Bridge Group 12A - Sandy Bottom

NOTICE TO PROSPECTIVE BIDDERS

ADDENDUM NO. 2 Prospective bidders and all concerned are hereby notified of the following changes in the Plans, Specifications, Proposal and Distribution of Quantities for this contract. These changes shall be incorporated in the Plans, Specifications, Proposal and Distribution of Quantities, and shall become an integral part of the Contract Documents.

REPLACEMENT OF
SANDY BOTTOM BRIDGE No. 257

DECK PLAN, SECTIONS
AND TOP OF FORMS

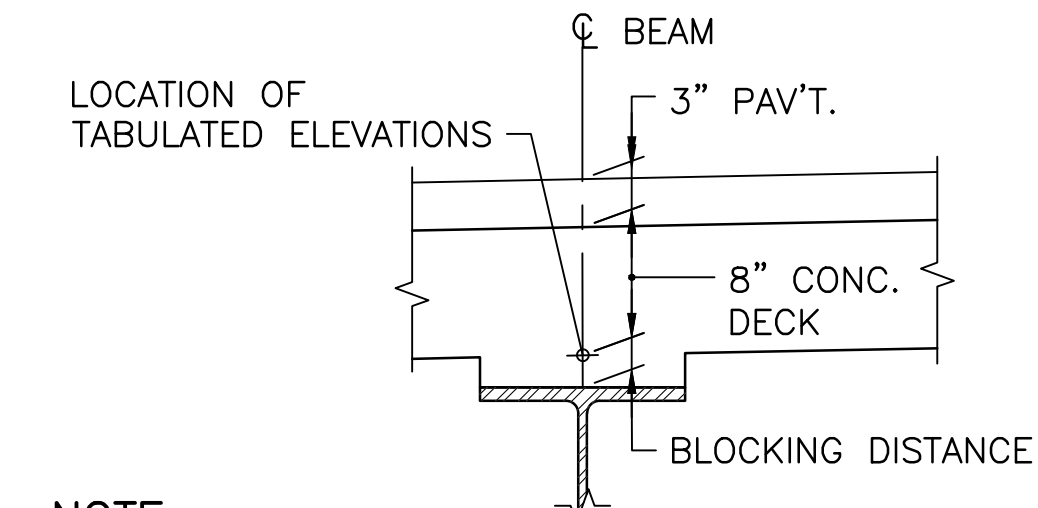
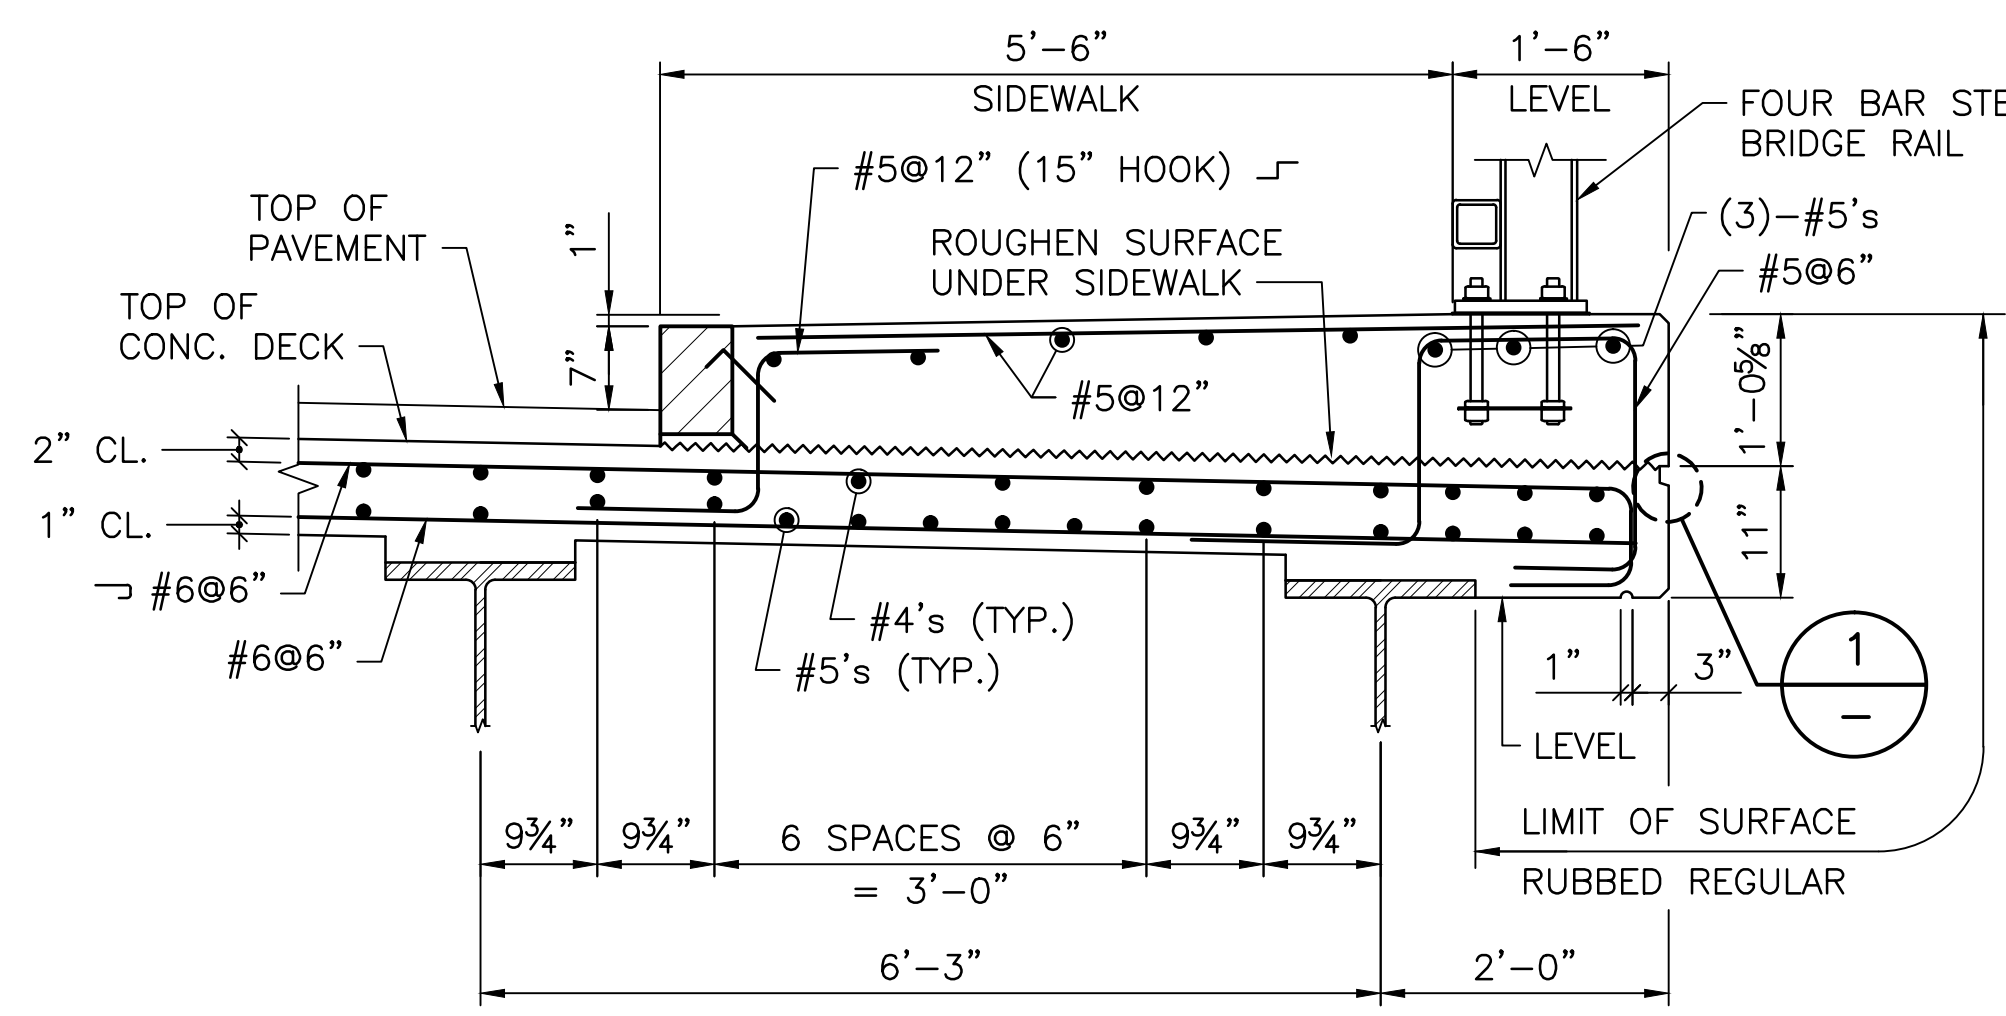
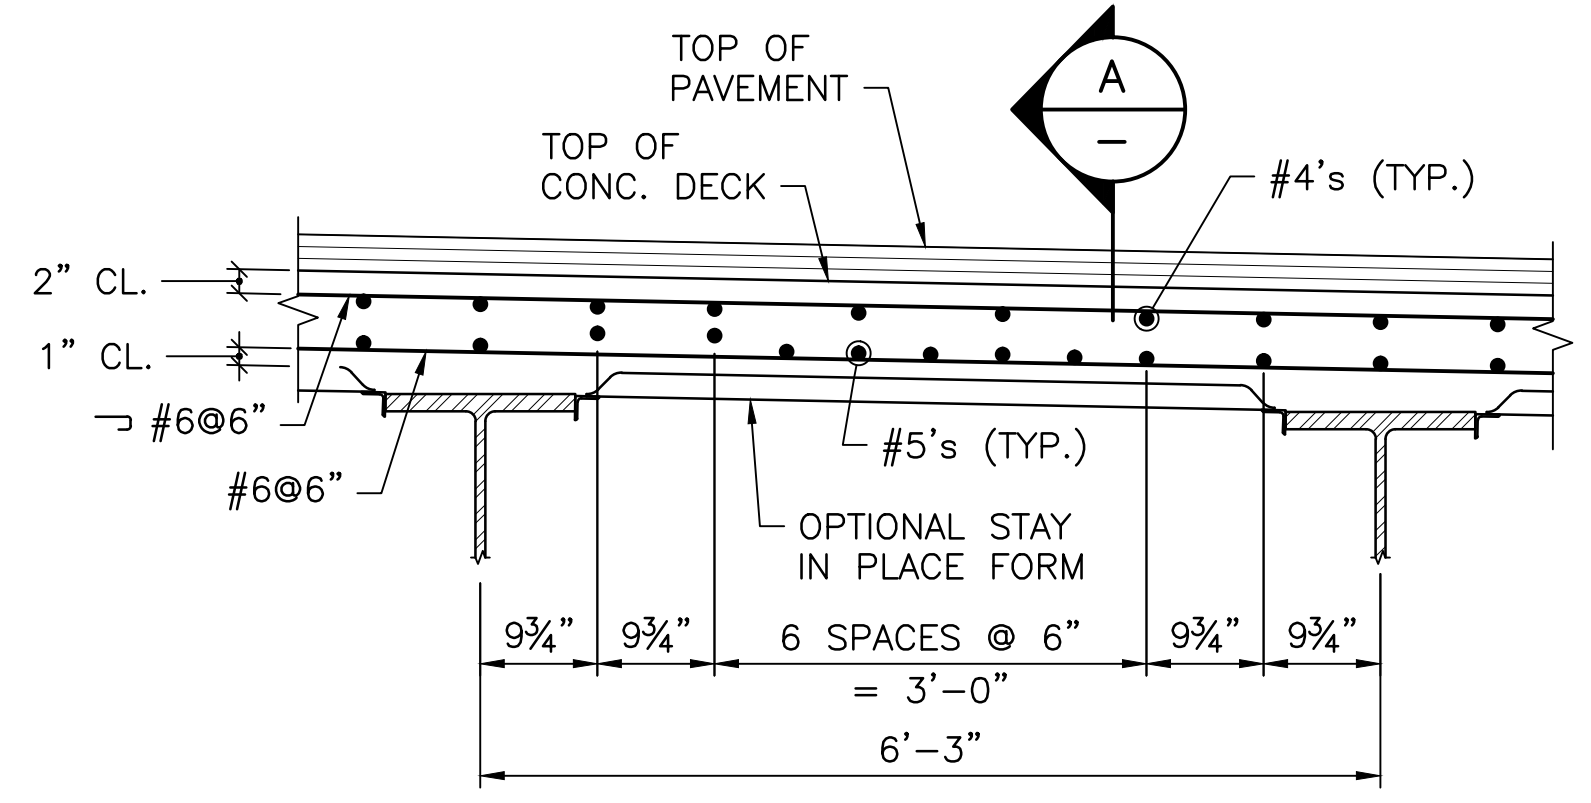
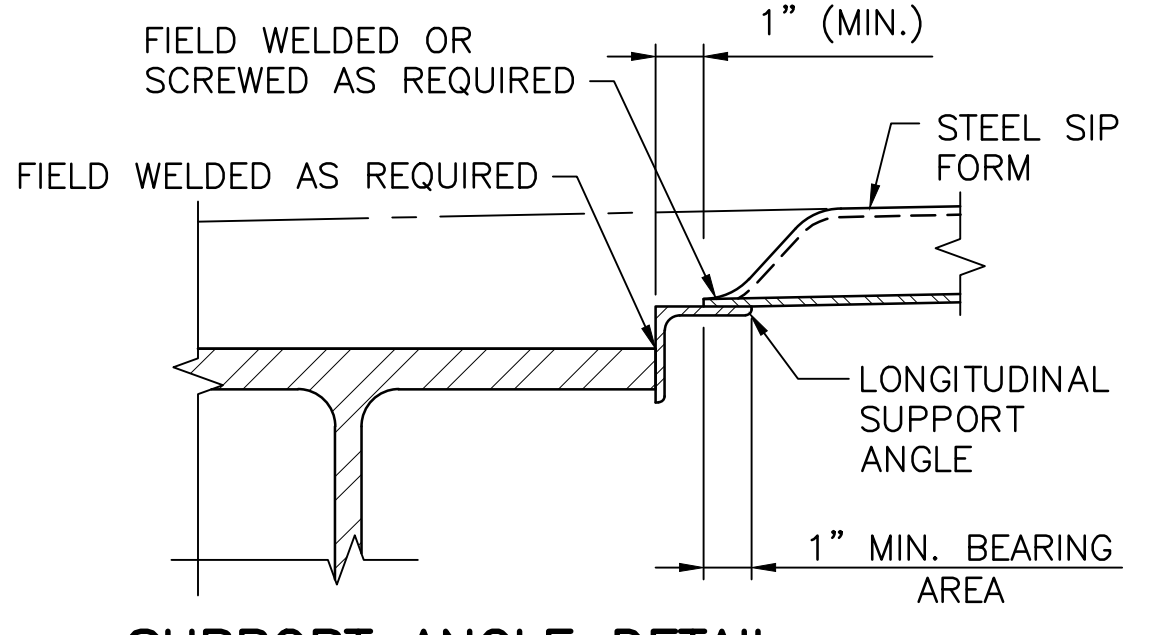
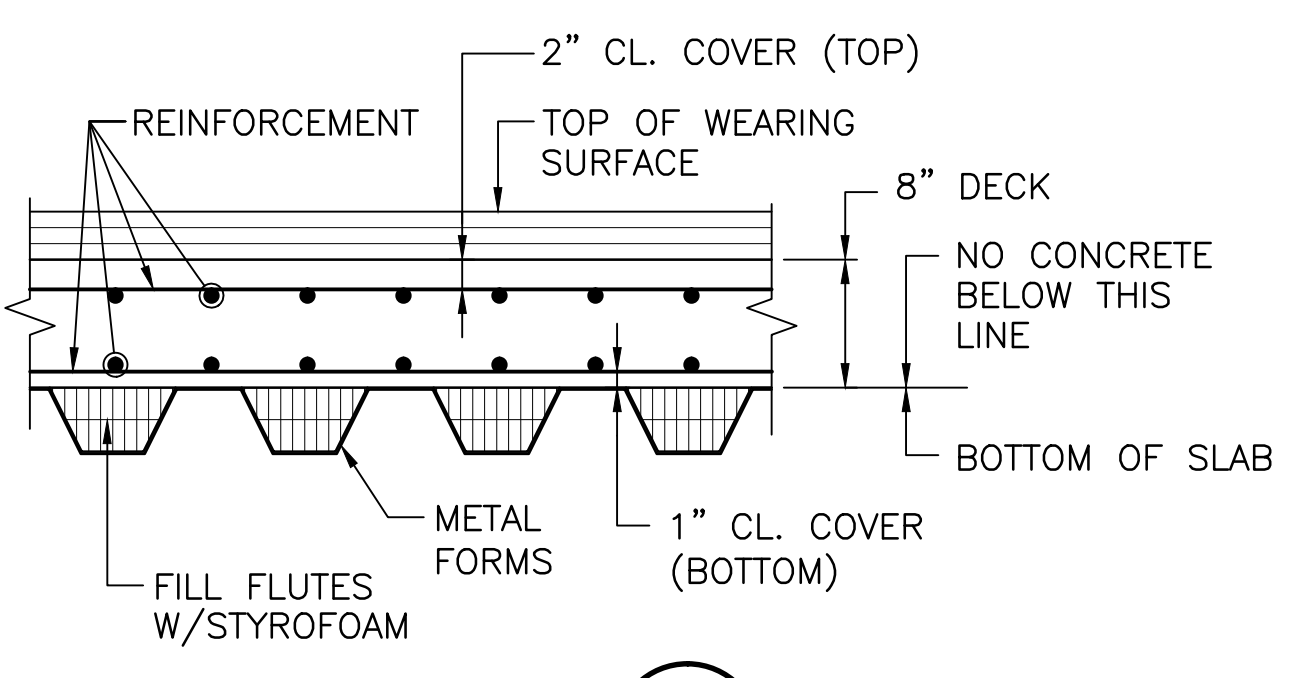
Remove Sheet No. 42 in its entirety and replace it with revised Sheet No. 42 (R-1) attached to this Addendum No. 2. Deck Note #5 has been removed.
